<p>نگهداشت و افزایش تولید میدان نفتی بینک سطح الارض</p> <p>احداث ردیف تراکم گاز در ایستگاه جمع آوری بینک</p>																									
<p>شماره پیمان: ۰۵۳ - ۰۷۳ - ۹۱۸۴</p>

<table><tr> <th colspan="8">HAZOP REPORT FOR COMPRESSOR STATION</th> </tr><tr> <td>D00</td> <td>0004</td> <td>RT</td> <td>GE</td> <td>120</td> <td>PEDCO</td> <td>GCS</td> <td>BK</td> </tr></table>

The purpose of this document is to provide the results of “HAZOP Study” for **Binak Oilfield Development – Surface Facilities; New Gas Compressor Station**.

PK-2101 (NOTE 2.8)
DEHYDRATION PACKAGE

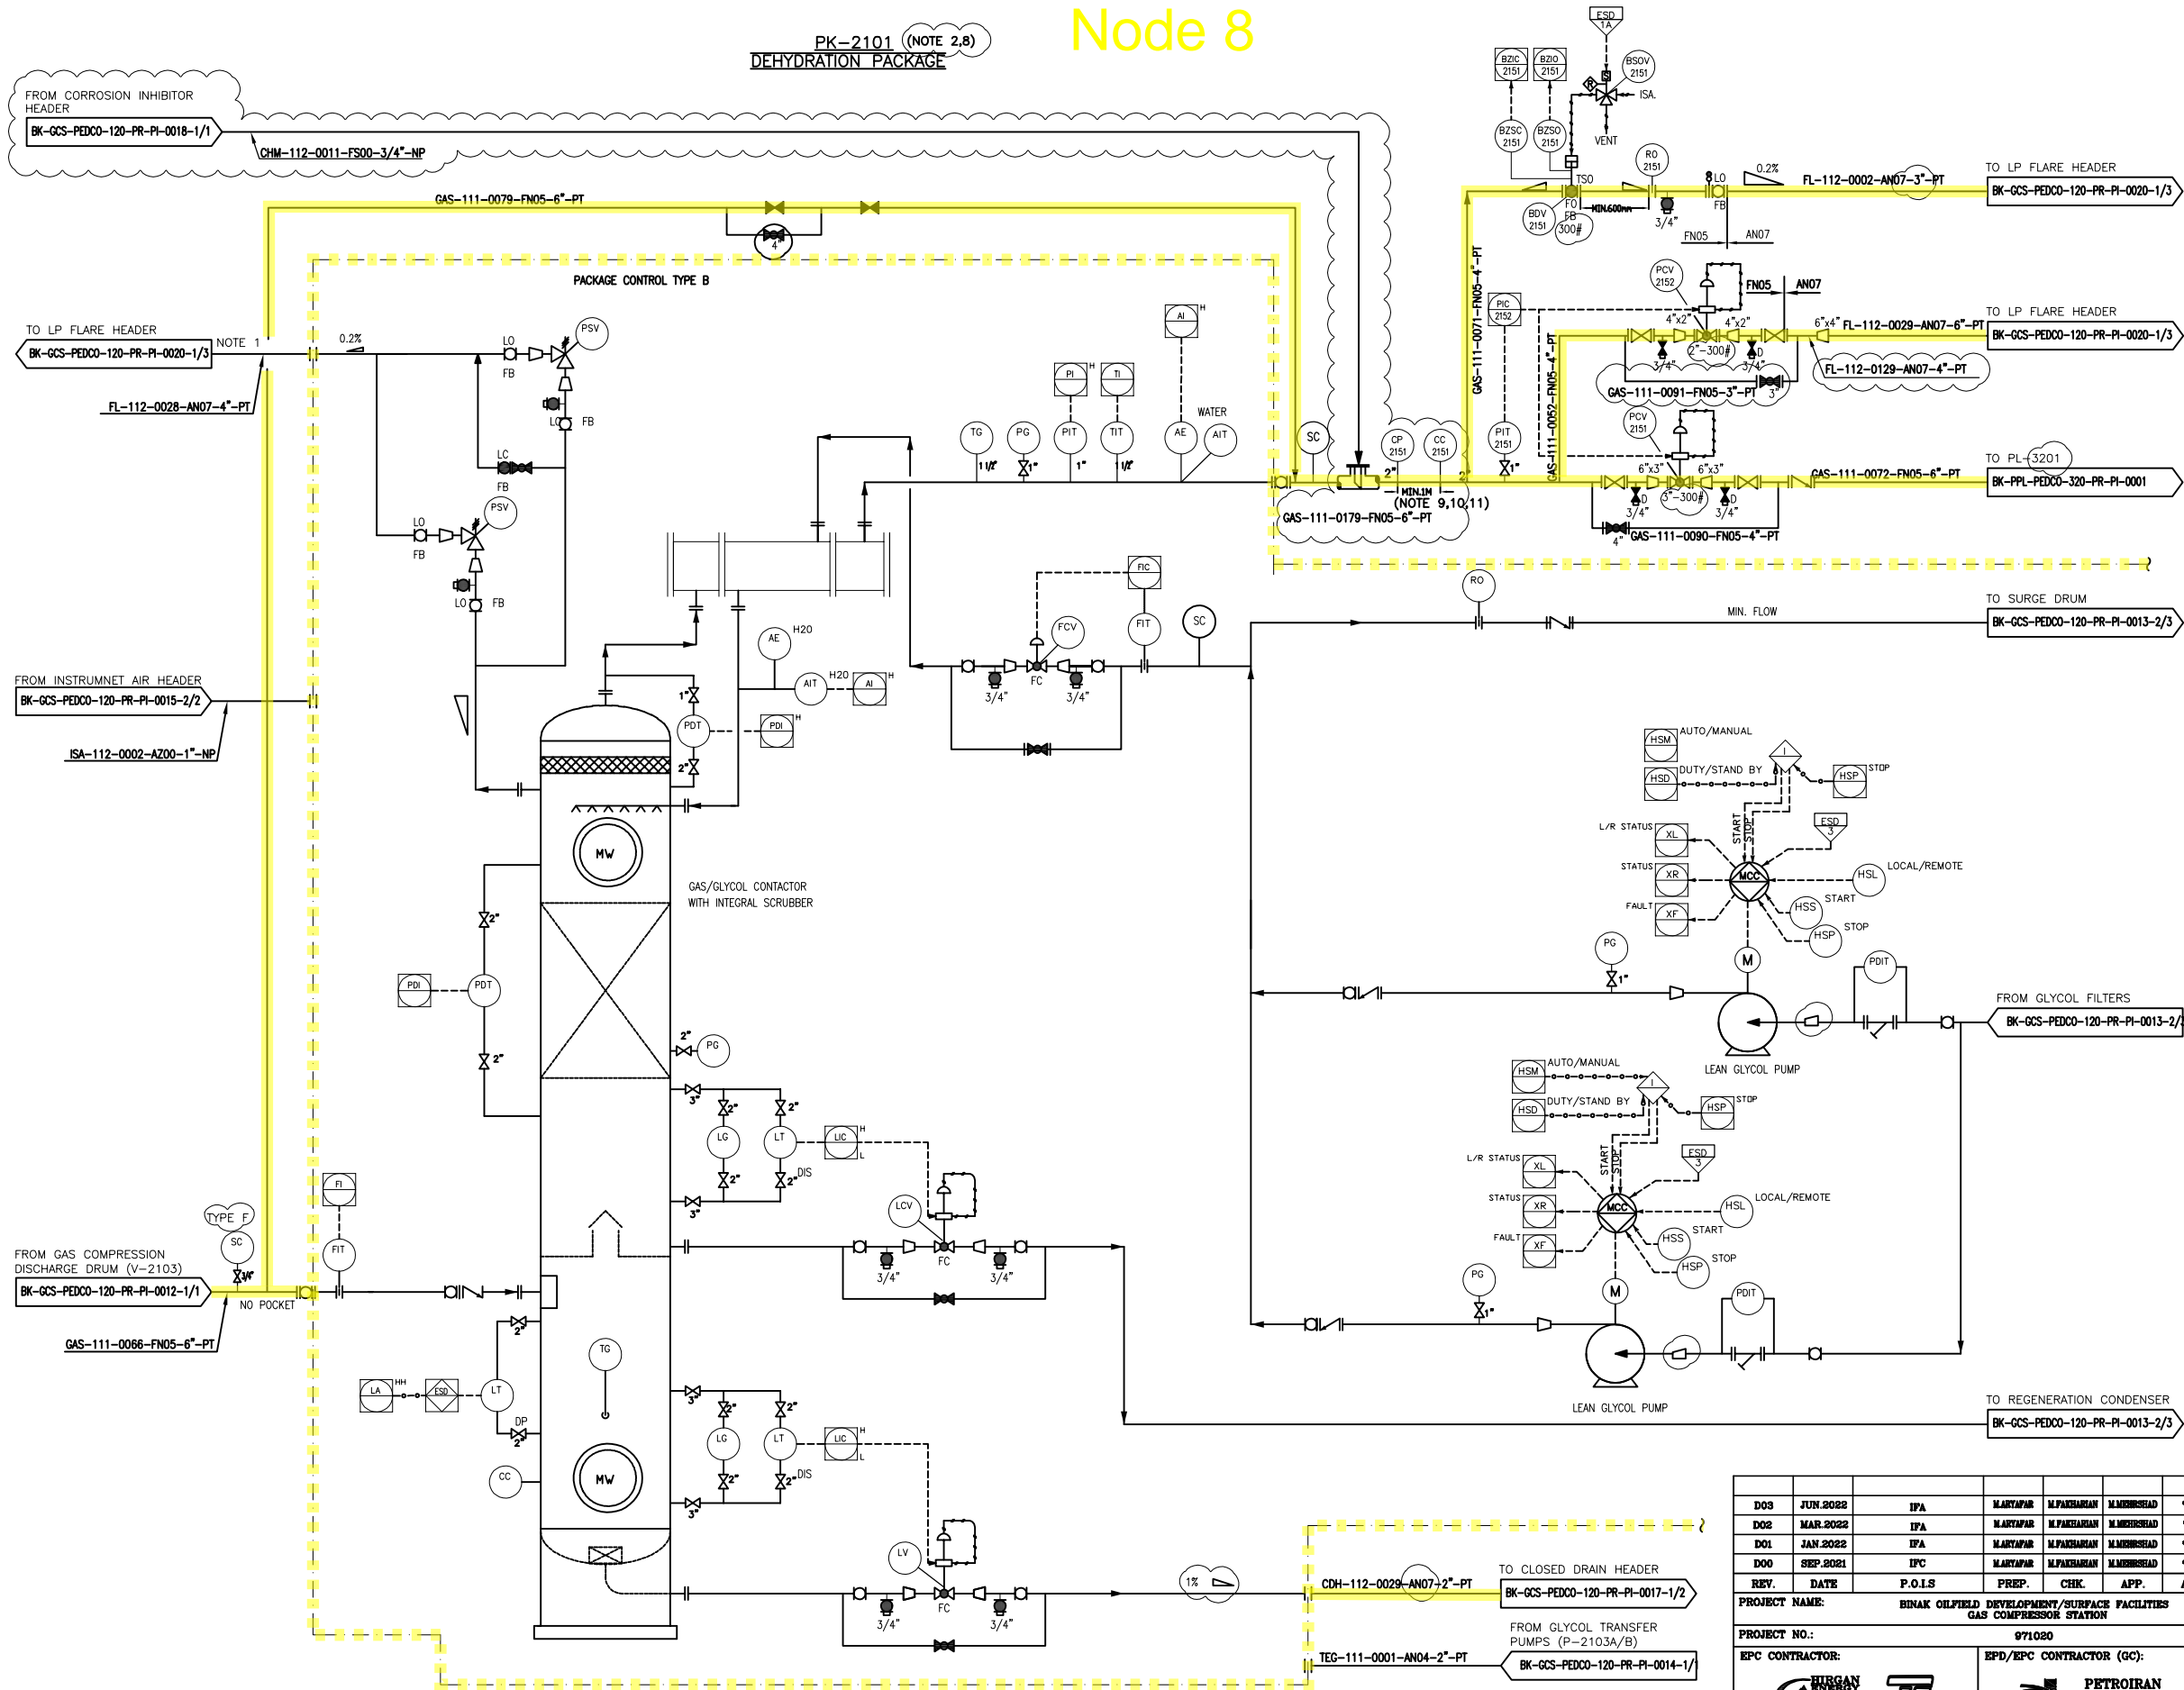
56. Define high alarm on PIC-2152.	Consequences: 8.1.1.1	Contractor	Closed
57. Show dedicated control blocks for PCV-2152 and PCV-2151.	Consequences: 8.1.1.1	Contractor	Closed

64. Show on P&ID of dehydration package detail of corrosion inhibitor injection valving.	Consequences: 8.6.1.1	Contractor	Closed
65. Equalizing valve on bypass of dehydration package should be 2" and gate valve on this bypass should be changed to ball valve.	Consequences: 8.7.1.1	Contractor	Closed

Recommendations	Place(s) Used	Responsibility	Status
67. Show on P&ID of dehydration package, BMS and min required signals to/from plant DCS and ESD.	Consequences: 8.7.1.1	Contractor	Closed

68. HAZOP study of dehydration package shall be performed with participation of package vendor.	Consequences: 8.7.1.1	Contractor	Closed
69. Correct on P&ID min flow (including RO) of P-2103A/B to be connected directly to nozzle B2 of TK-2102.	Consequences: 9.1.1.1	Contractor	Closed

TK-2102 LEAN GLYCOL STORAGE TANK

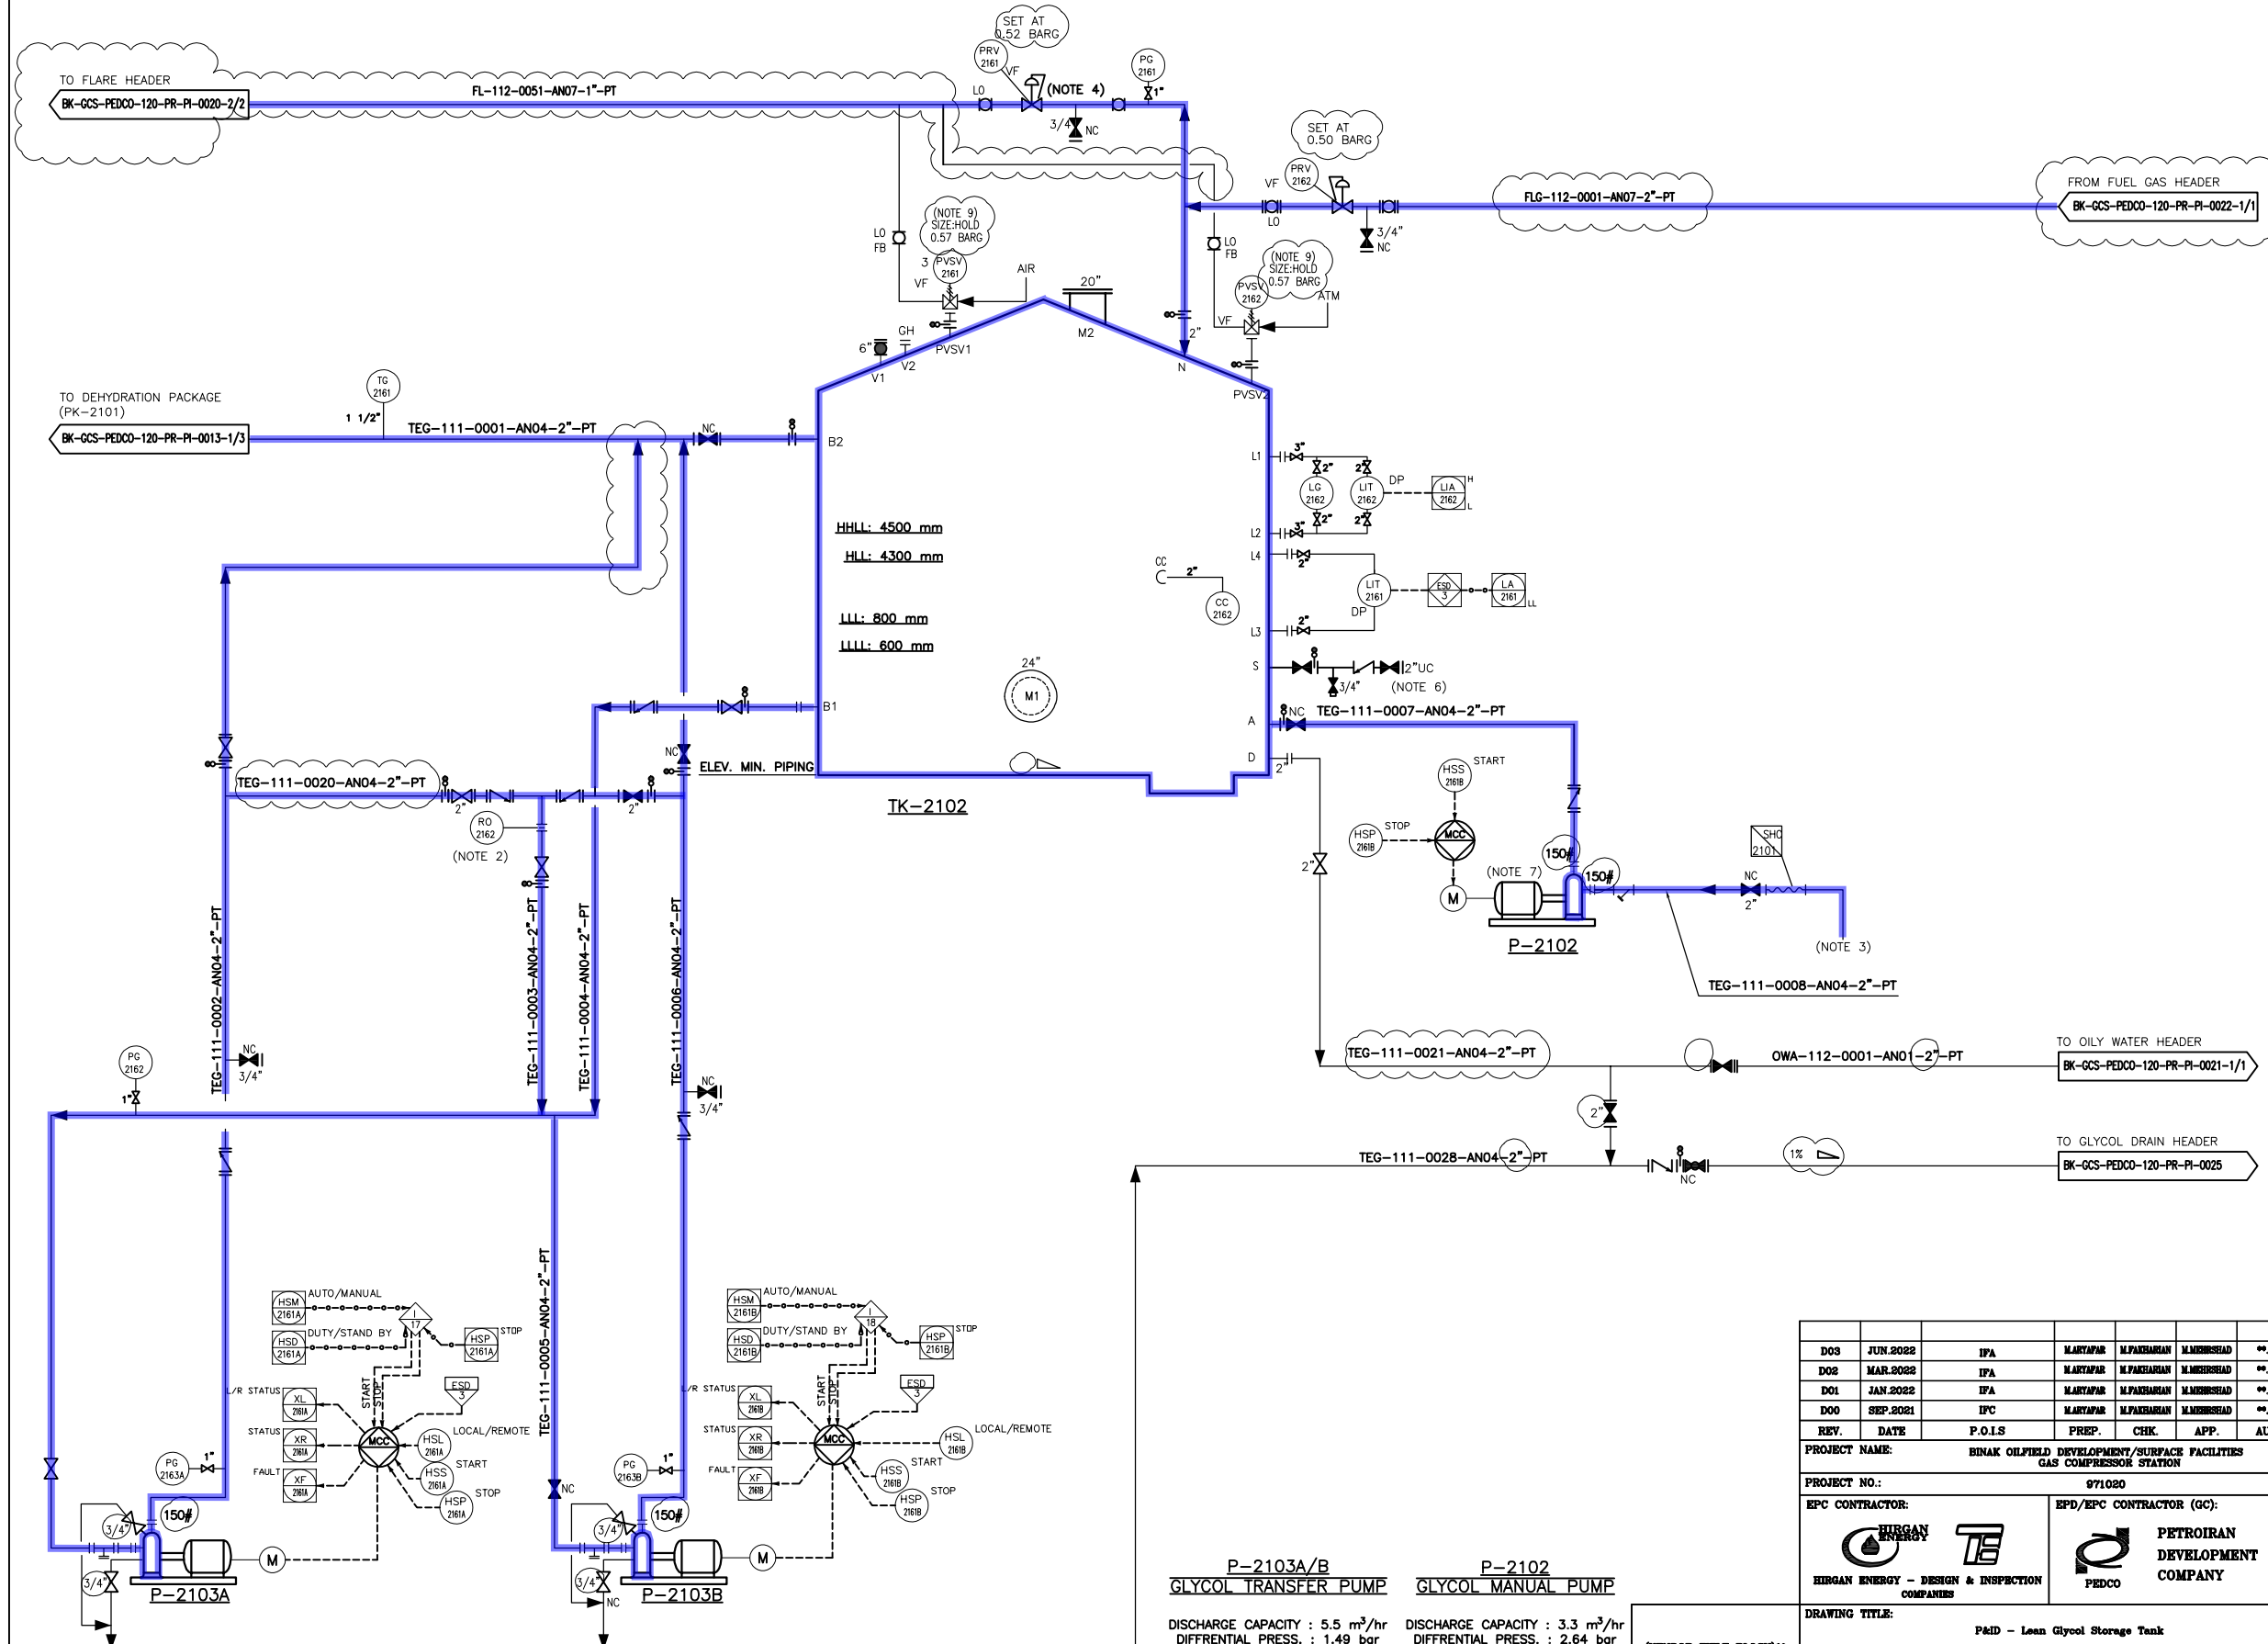
70. Remove auto/manual signal from P-2103A/B.	Consequences: 9.1.1.1	Contractor	Closed
71. Consider check valve on glycol line from P-2103A/B to PK-2101.	Consequences: 9.3.1.1	Contractor	Closed

76. Show vacuum set point of PVS-2161/2162.	Consequences: 9.5.1.1	Contractor	Closed
77. LIT-2161 and LIT-2162 should be readable at grade in loading area.	Consequences: 9.6.1.1	Contractor	Closed

78. Consider spectacle blind on 2" drain nozzle D of TK-2102.	Consequences: 9.8.1.1	Contractor	Closed
79. Remove check valve on suction of P-2103A/B.	Consequences: 9.10.1.1	Contractor	Closed

80. Correct P&ID of glycol tank and show nozzle A at top of tank.	Consequences: 9.10.1.1	Contractor	Closed
81. Consider PG on discharge of P-2102.	Consequences: 9.10.1.1	Contractor	Closed

V-2203
INSTRUMENT AIR RECEIVER

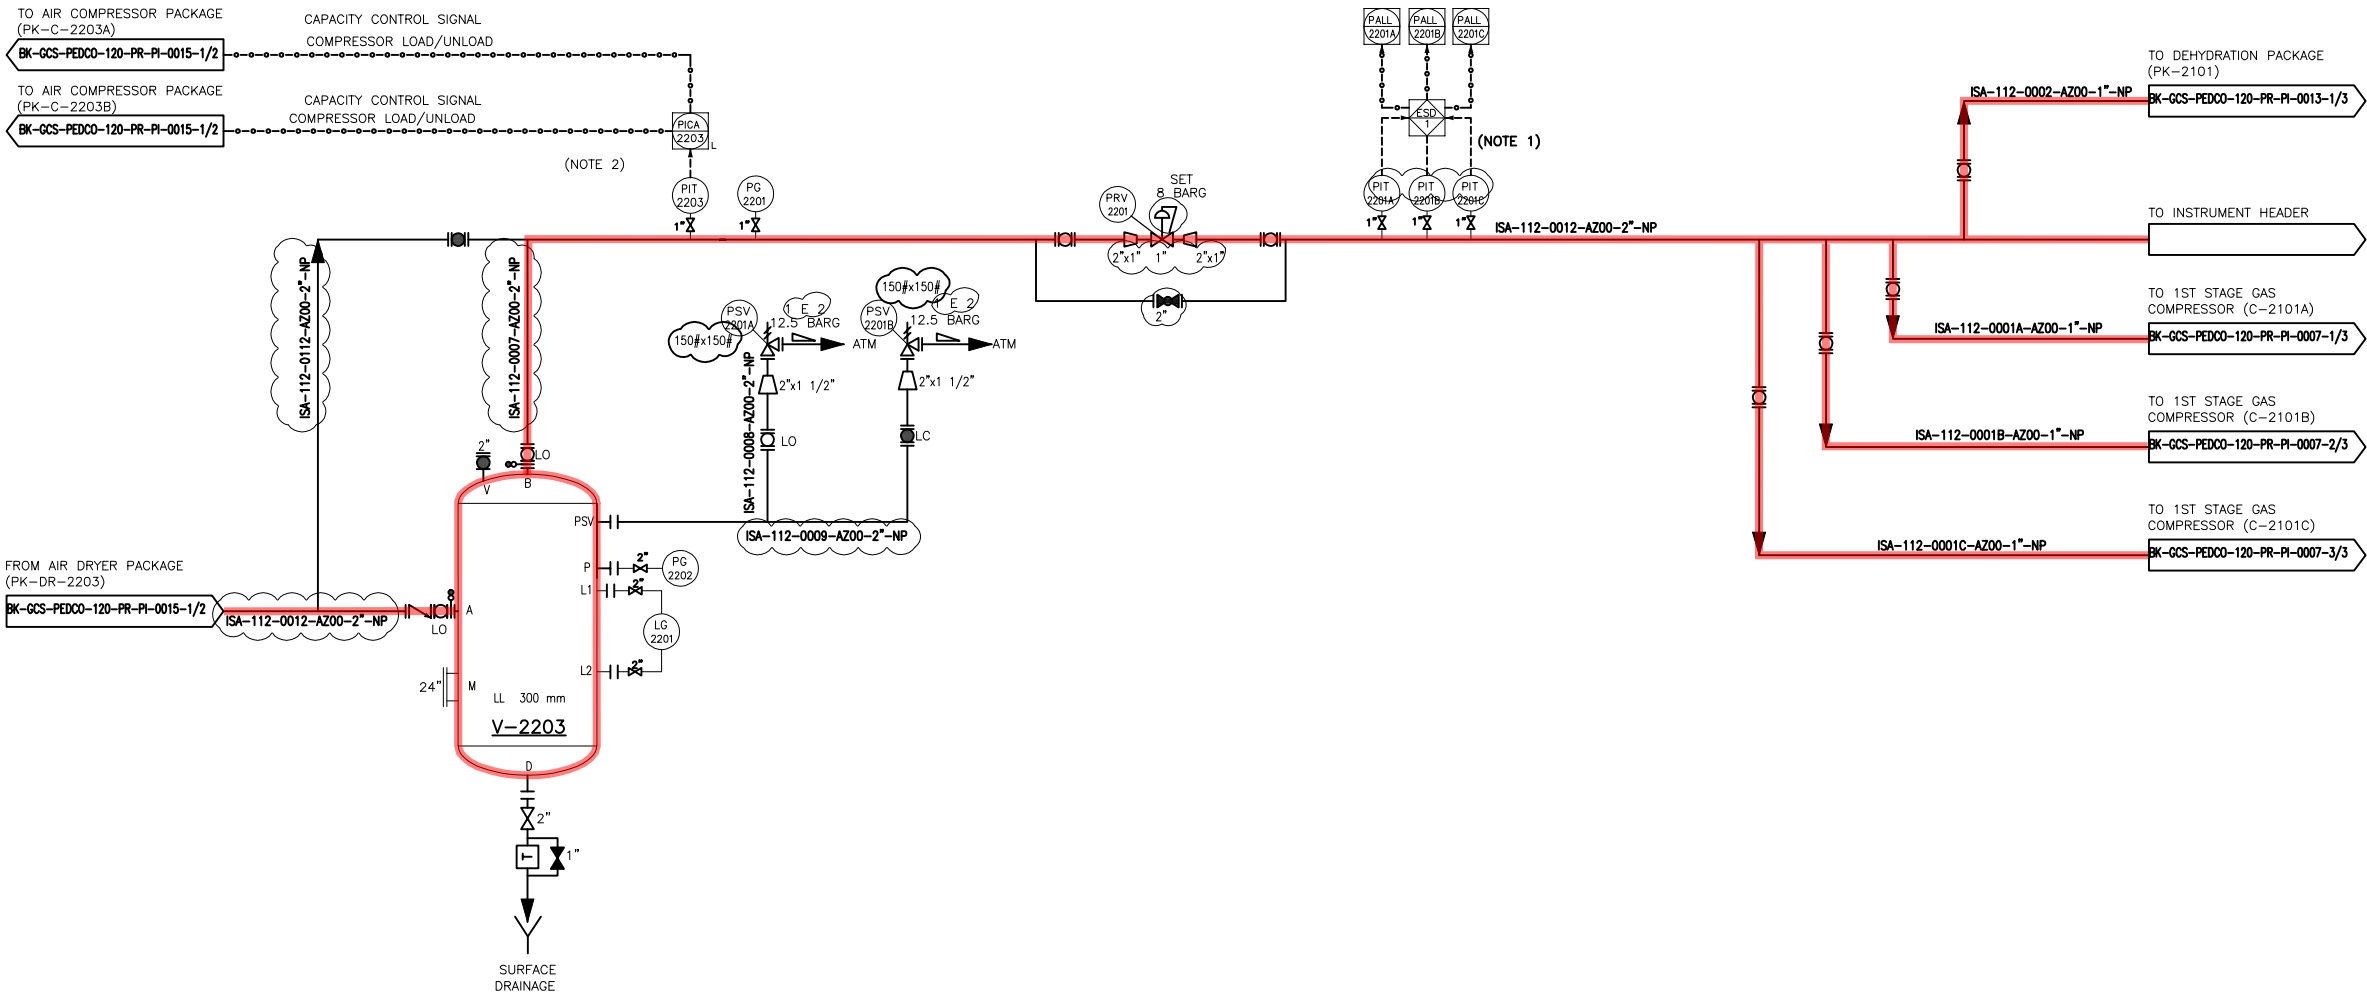
85. Remove ESDV-2231 and consider solenoid on PCV-2201 to close valve by ESD-3.	Consequences: 10.1.3.1	Contractor	Closed
86. Remove mechanical trap from V-2203 and consider mechanical trap for wet air KO drum.	Consequences: 10.7.1.1	Contractor	Closed
